City of Portland, Maine – Building or Use Permit Application 389 Congress Street, 04101, Tel: (207) 874-8703, FAX: 874-8716

Location of Construction: 120 Veranda St		Owner: Wayne & Julie Marsteller	Phone: 822-2201(W) 780-0748 (H)	Permit # 990210
Owner Address: 139 Sherwood St 04103		Lessee/Buyer's Name:	Phone:	<div style="border: 2px solid black; padding: 5px; text-align: center;"> PERMIT ISSUED Permit Issued: MAR 15 1999 CITY OF PORTLAND </div>
Contractor Name: Owner		Address:		
Past Use: 1-fam	Proposed Use: Same	COST OF WORK: \$ 10,000.00	PERMIT FEE: \$ 70.00	Zone: CBL: 431-M-006 Zoning Approval: <i>Remain 1 family</i>
Proposed Project Description: Misc Interior Renovations		FIRE DEPT. <input type="checkbox"/> Approved <input type="checkbox"/> Denied Signature:	INSPECTION: Use Group: Type: Signature:	
Permit Taken By: MG		Date Applied For: 11 March 1999

BUILDING PERMIT REPORT

REASON FOR PERMIT: Interior Renovations

EXHIBIT "A" FIRST FLOOR PLAN

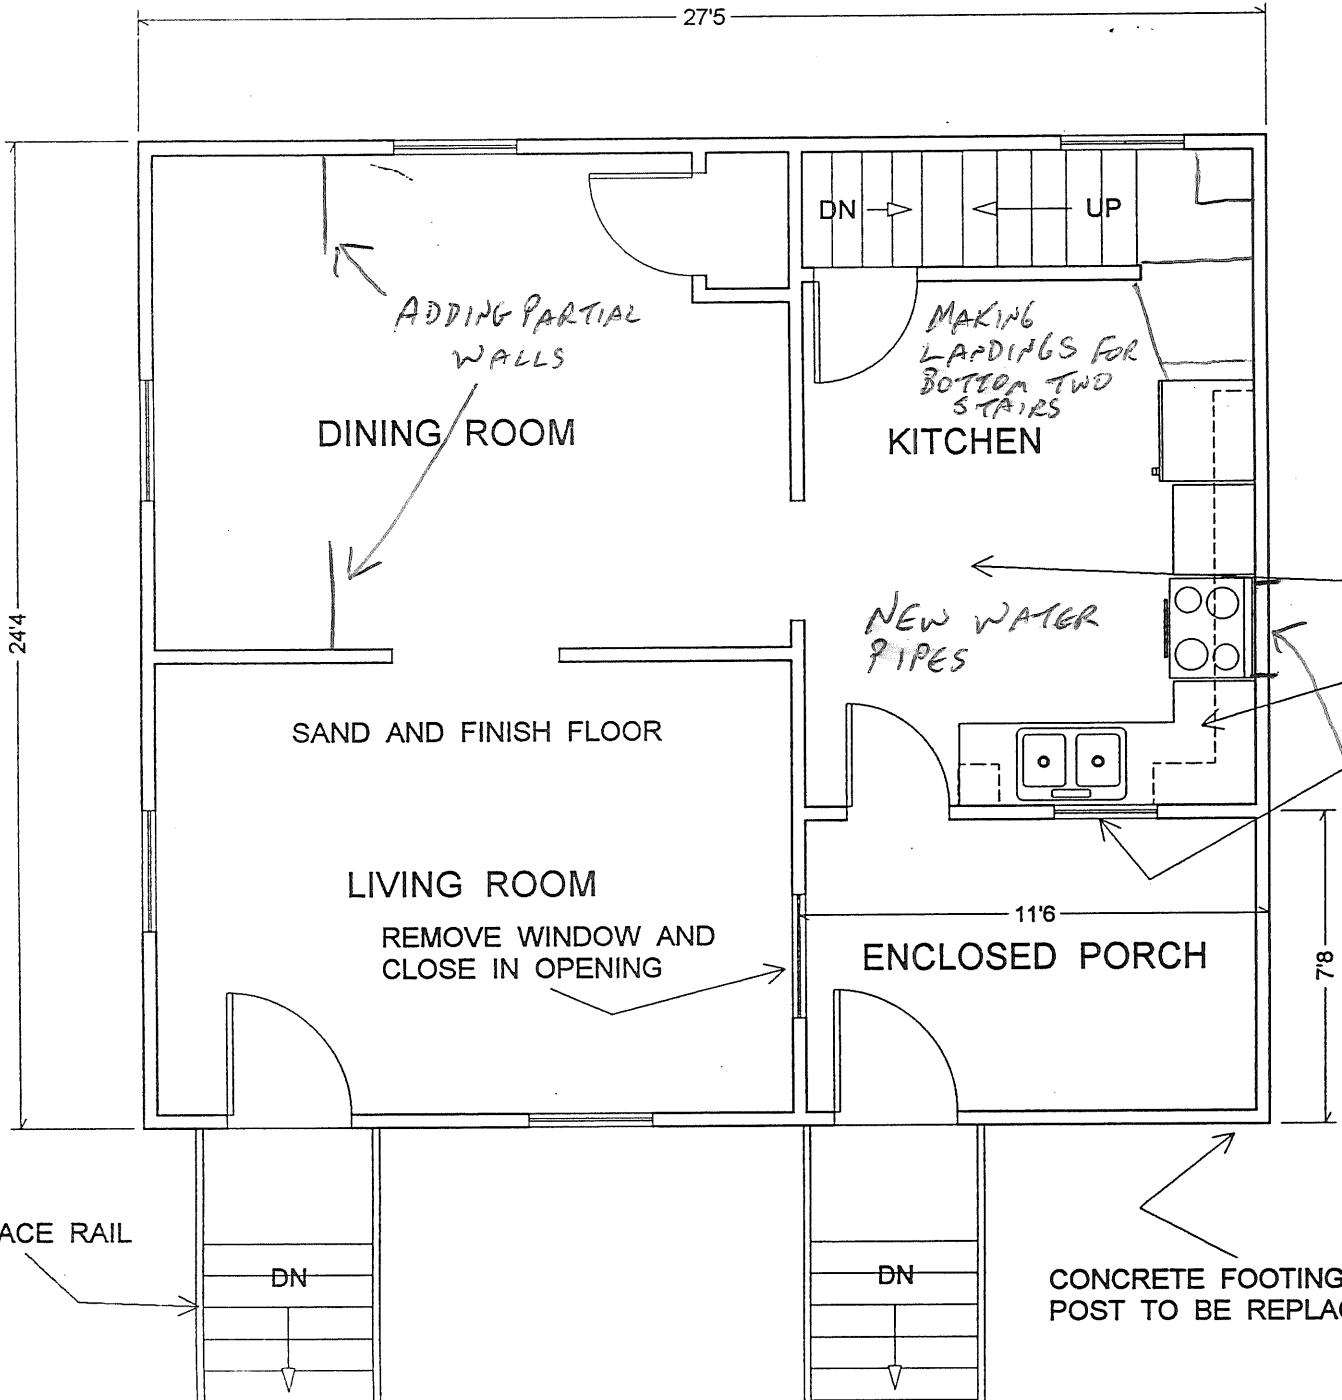
Framing - retrofitting existing home - need to add adequate
headers over areas where new windows were installed.
